Subject: AP1000 Response to Request for Additional Information (SRP 6)

Response to Request for Additional Information on SRP Section 6

RAI Response Number: RAI-SRP6.2.4-SPCV-04  
Revision: 0

Figure 2.2.1-1  
Containment System

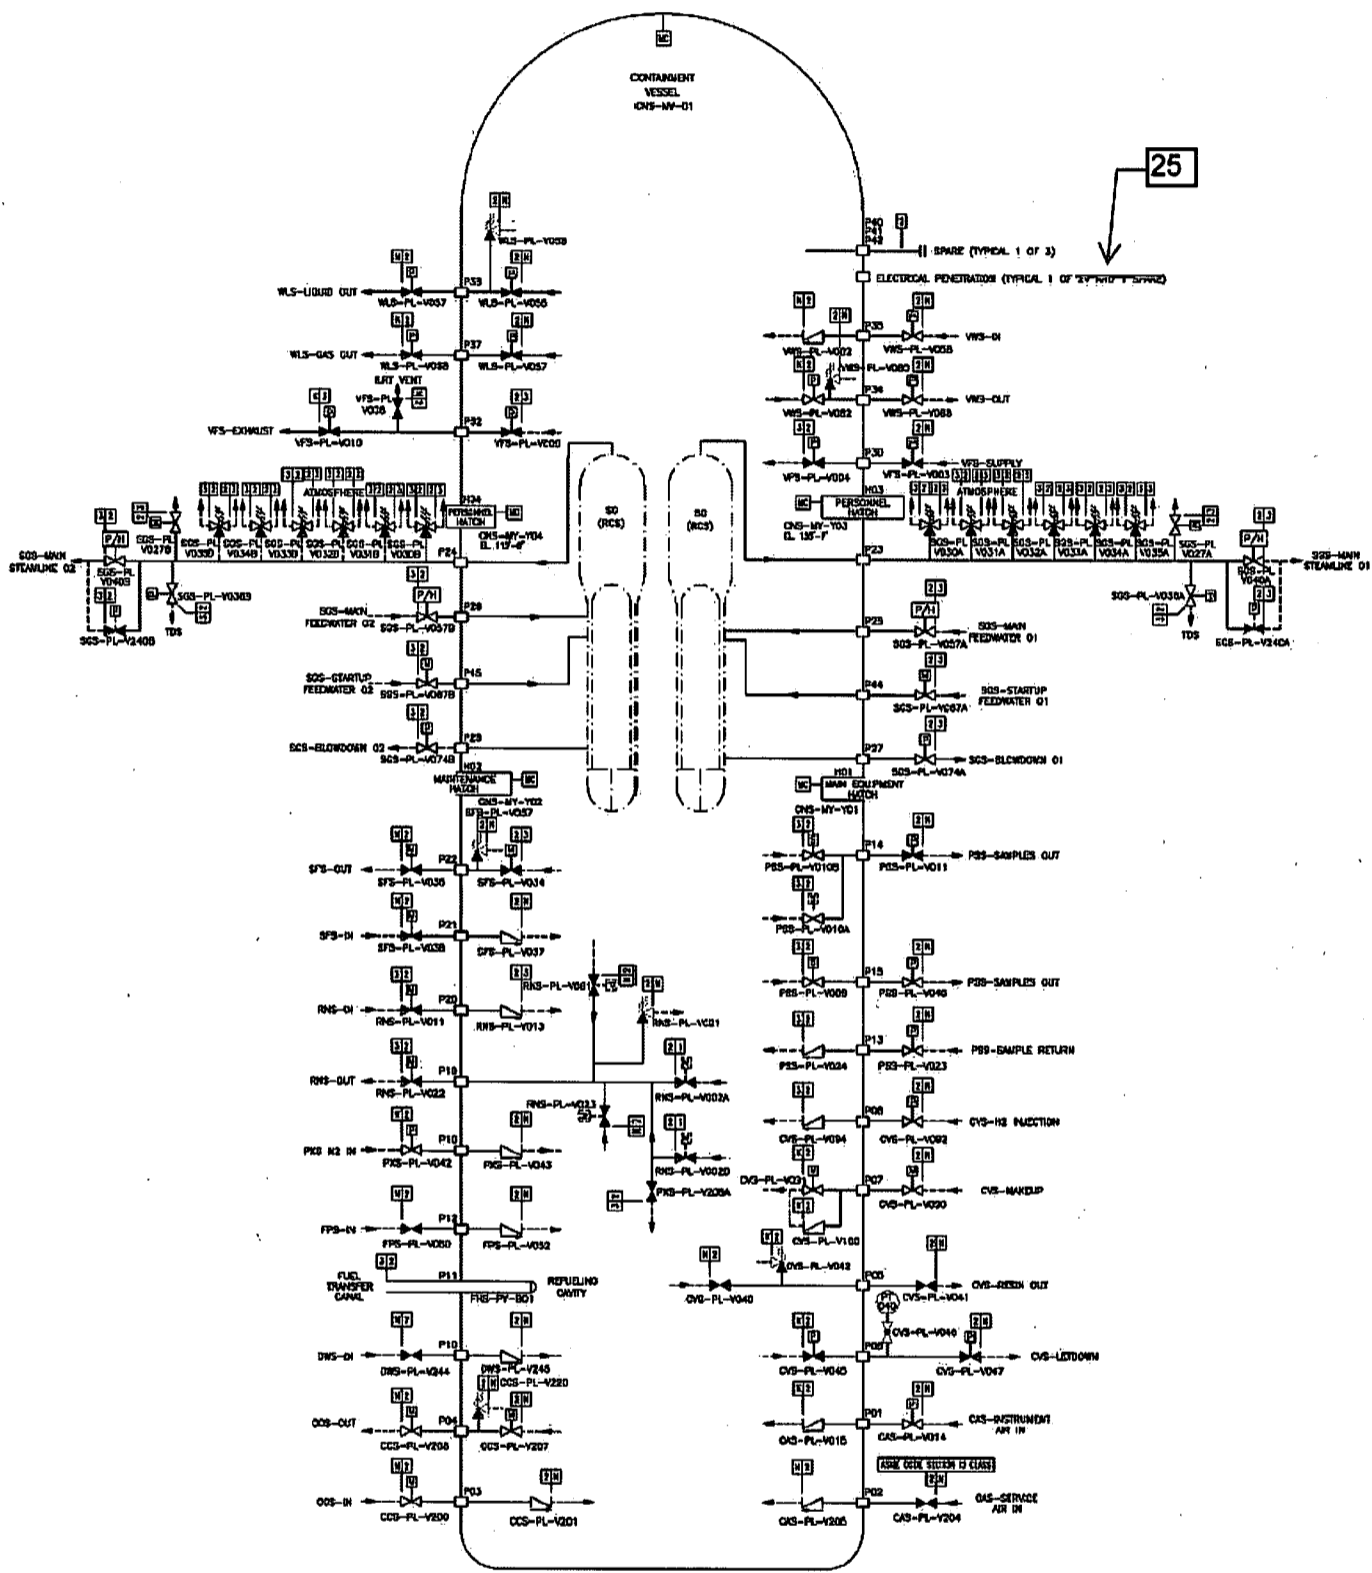
Westinghouse, in DCD revision 16, revised Tier 1, Table 2.2.1-1 and Figure 2.2.1-1 to reflect this approved change. However, in DCD revision 17, Figure 2.2.1-1 was revised again.

The DCD Rev. 17, Tier 1, Figure 2.2.1-1 with the note "1 of 24 and 1 spare" is incorrect and should be replaced by the DCD Rev. 16, Figure 2.2.1-1 where the note "1 of 25" is indicated next to the typical electrical penetration. This should be corrected.

Westinghouse will revise the note on DCD, Tier 1, Figure 2.2.1-1 to indicate "1 of 25" next to the typical electrical penetration.
